U.S. Department
of Transportation

**Federal Highway
Administration**

MAR 14 1986

This is in response to your February 20 letter to Mr. Thomas O. Willett requesting the Federal Highway Administration (FHWA) acceptance of your company's number 69338-002 Cast Aluminum Transformer Base and your number 67238 Impact Safety Coupling. Submitted with your letter was a report by the Southwest Research Institute, "Pendulum Test Report of Lighting Support Pole Tests H-1, H-2, and H-3."

TITLE <i>Impact Safety Couplings</i>	
	CUSTOMER	
	SCALE <i>Full</i>	DATE <i>1.22.85</i>
	BY <i>L.W.</i>	CHKD. NO.
CHKD.	<i>867238</i>

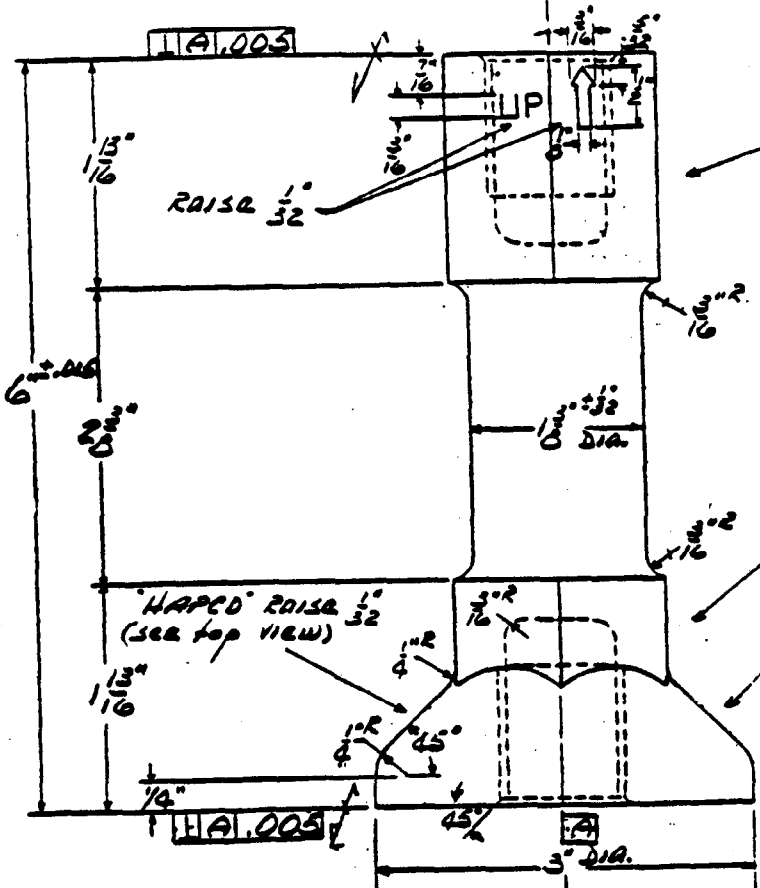
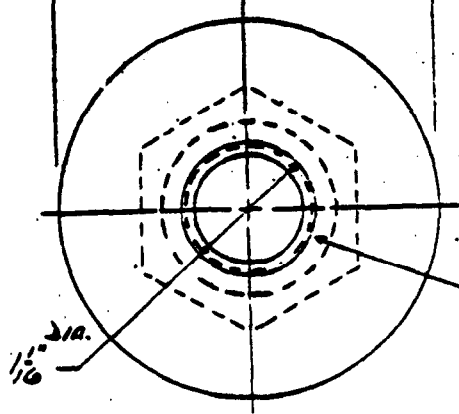
Four Impact Safety Couplings mounted under a 556-pound aluminum luminaire support system with a 15-foot mast arm and a 54-foot mounting height were tested at 20 m.p.h. Impact was with an 1,800-pound pendulum with a crushable nose simulating the front end of a mini-compact automobile (test H-3). The change in velocity was 5.0 feet-per-second. The calculated velocity change for a 60 m.p.h. test was 9.6 feet-per-second. The coupling is shown on the enclosed Drawing Number B 67238 "Impact Safety Coupling."

This information shows that the actual test and calculated changes in vehicle velocity and pole stub height for the Impact Safety Coupling meet the provisions of Section 7 of the 1985 American Association of State Highway and Transportation Officials "Standard Specifications for Structural Supports for Highway Signs, Luminaires and Traffic Signals."

Therefore, the tested Impact Safety Coupling No. 67238 will be acceptable for use on Federal-aid projects, within the range of conditions tested, if proposed by a State. One of the test conditions was that the test pole was 10 inches in diameter and had a 1/4-inch wall thickness. Our acceptance does not extend to poles with greater base diameters or thinner walls.

This acceptance is limited to breakaway characteristics of the couplings and does not cover their structural features. Presumably, you will supply potential users with sufficient information on structural design and installation requirements to ensure proper base performance. We anticipate that the States will require certification from Hapco that couplings furnished
